**CRYSTAL HILLS SUBDIVISION
PRELIMINARY OVERALL DEVELOPMENT PLAN**

Re: Crystal Hills (Amending)

MDP/POADP # 359-A

The City Staff Development Review Committee has reviewed Crystal Hills (Amending) Master Development Plan M.D.P. (formerly POADP) Preliminary Overall Area Development Plan # 359-A. Please find enclosed a signed copy for your files. Your plan was accepted, however, please note the following:

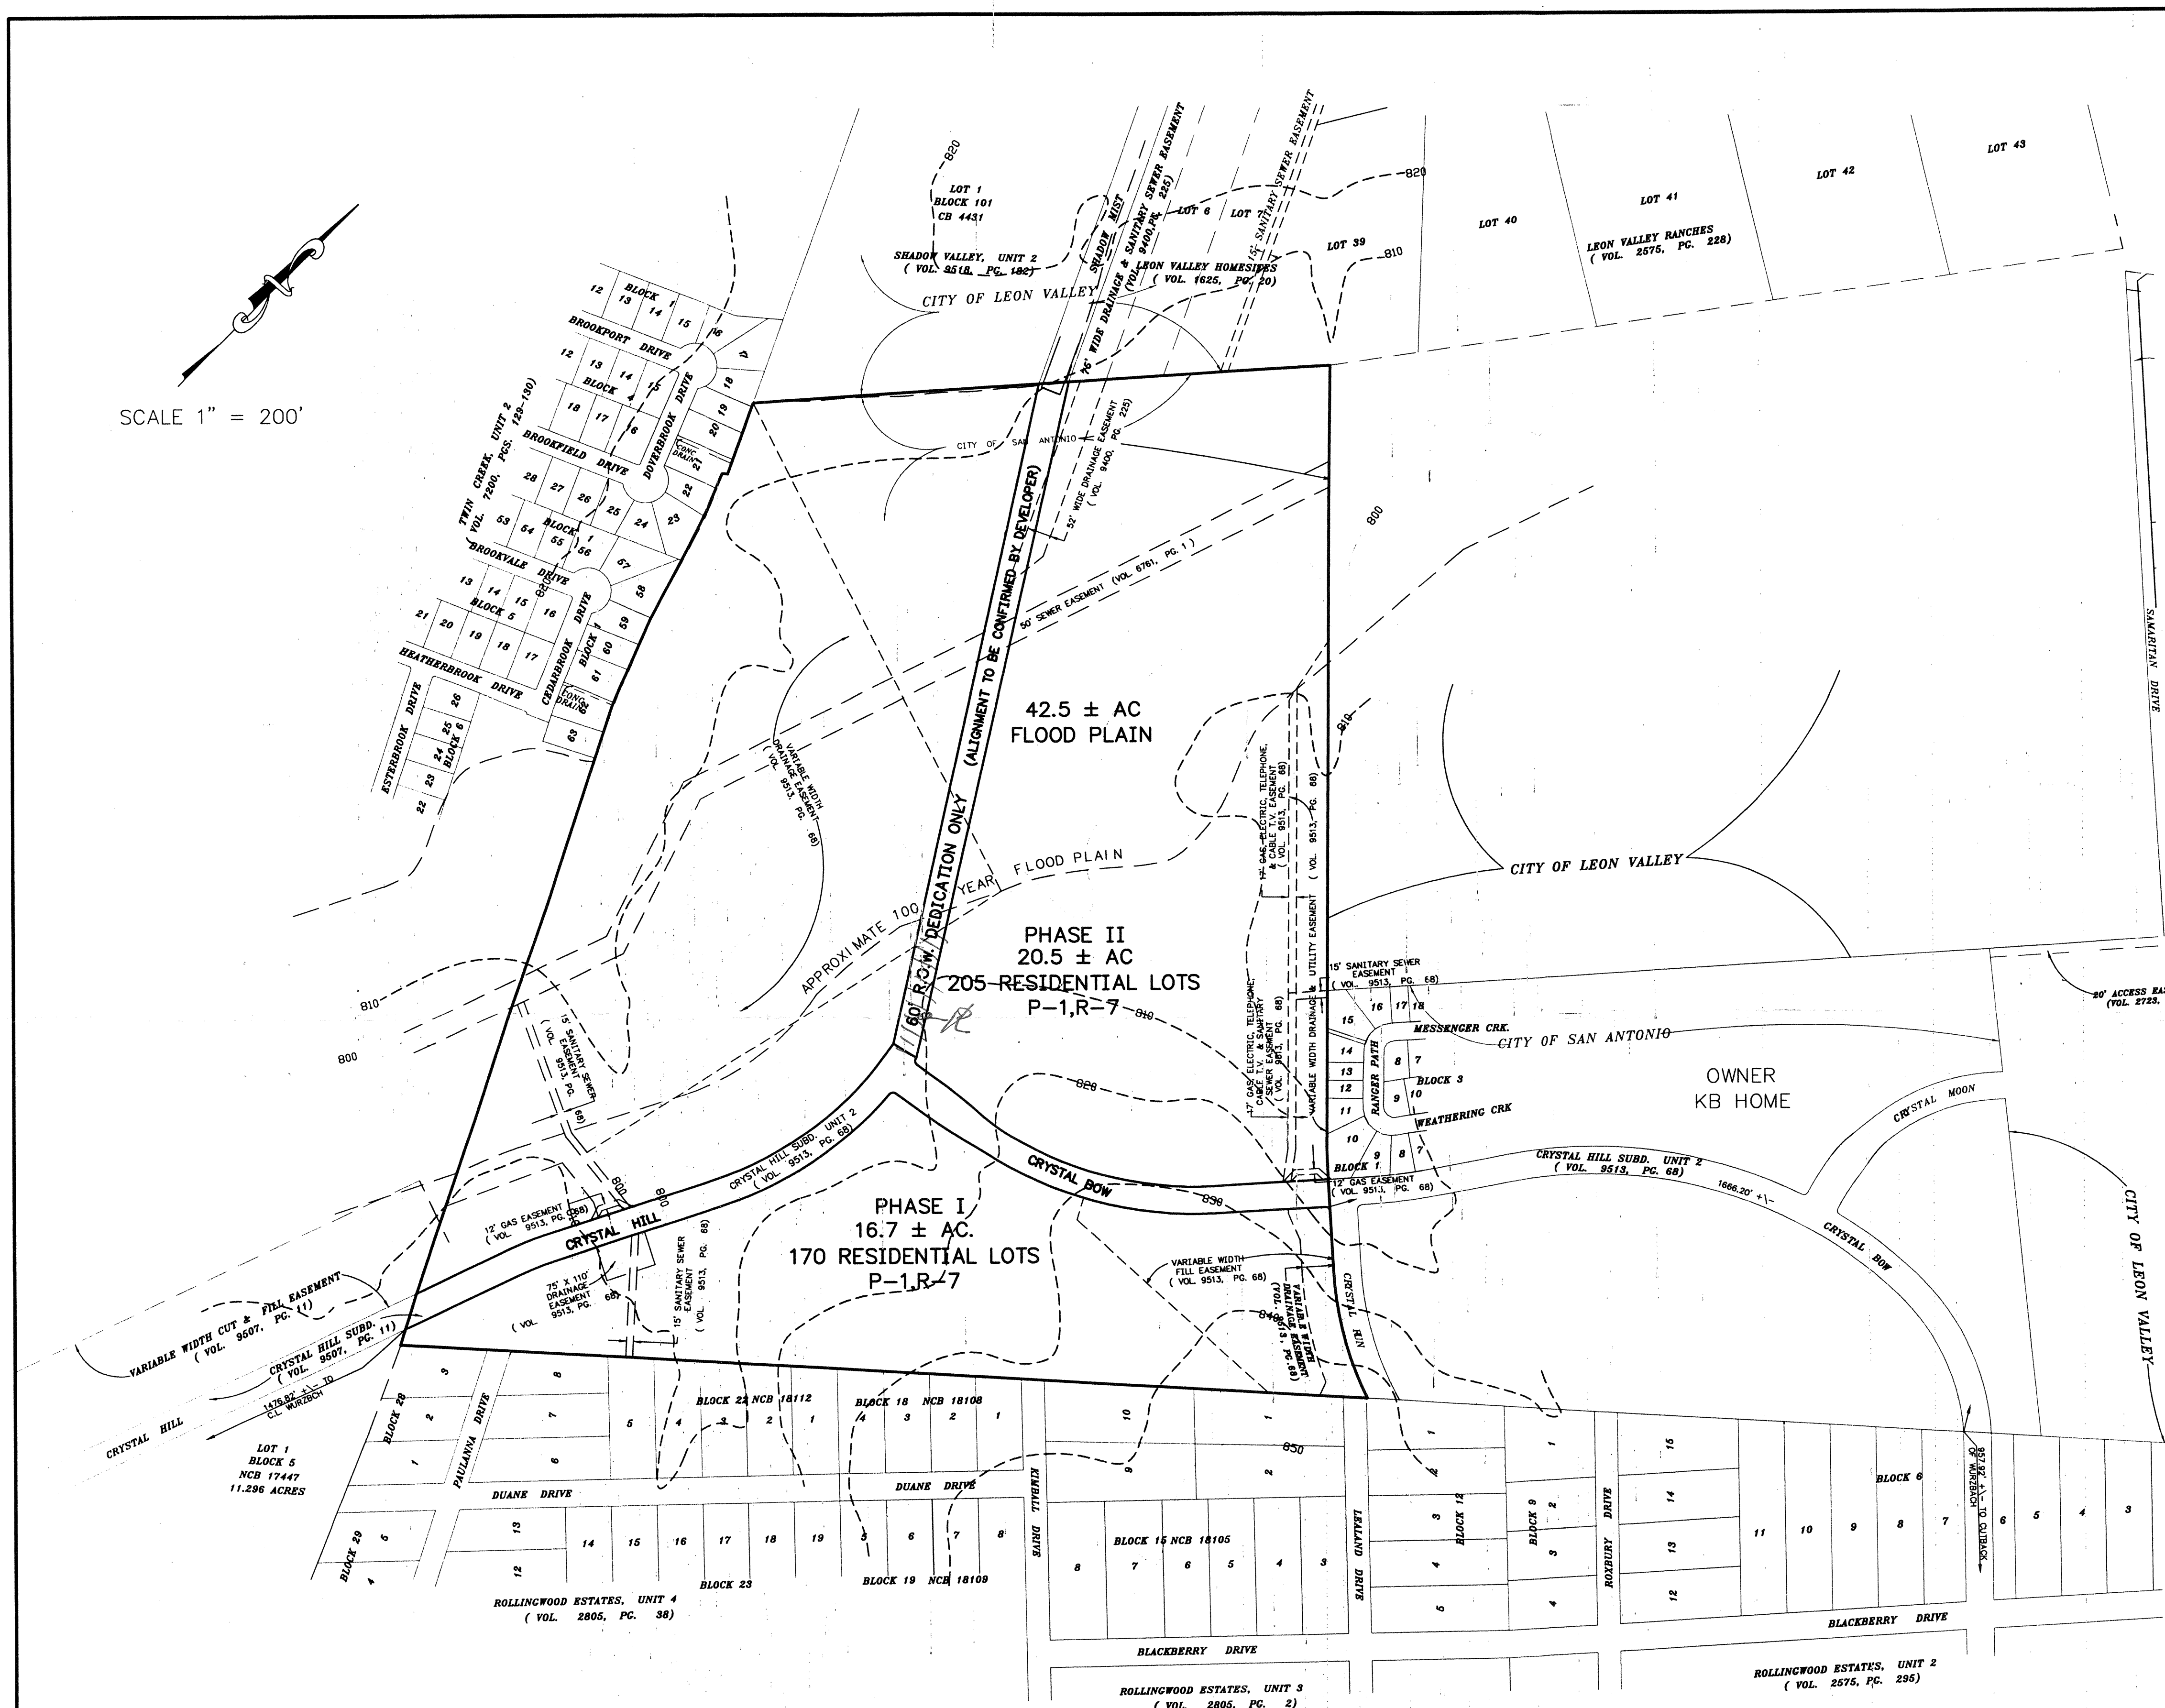
- In consideration of public safety and convenience, excessive grades by reason of topography should be avoided in street layouts and arrangements.
- Any access and R.O.W. issues along state facilities will need to be resolved with the Texas Department of Transportation (TXDOT). For information about these requirements you can contact TXDOT at 615-5814.

- Development Services, Engineering Section has indicated as part of their conditional approval, residential lots will not be allowed to front the collector streets. The sixty feet of right-of-way dedication will be for the purpose of providing the northern extension of Crystal Hill into Shadow Mist.

Comments: UNABLE TO REVIEW. PROPOSE POADP HAS NO LOCATION
MAP. UNABLE TO ASSESS LOCATION OF PROPOSE POADP IN
RELATION TO THOROUGHFARES

- show current zoning
- show proposed project as residential
- need rezoning for RUD & change from R-3
- need site plan show preservation of natural features for zoning

Comments: UNABLE TO REVIEW. PROPOSE POADP HAS NO LOCATION
MAP. UNABLE TO ASSESS LOCATION OF PROPOSE POADP IN
RELATION TO THOROUGHFARES

Comments: THERE ARE NO ROADWAYS, AS IDENTIFIED BY THE
PROPOSE MDP, ON THE MTP

Comments: Provide Row show dedication of Row for connection
to Shadow Mist.

Current zoning is P-1,R-7 (Case No. Z2001-122, June 28th, 2001)

Residential called out

Rezoning Done

Site plan had been submitted for Zoning Case
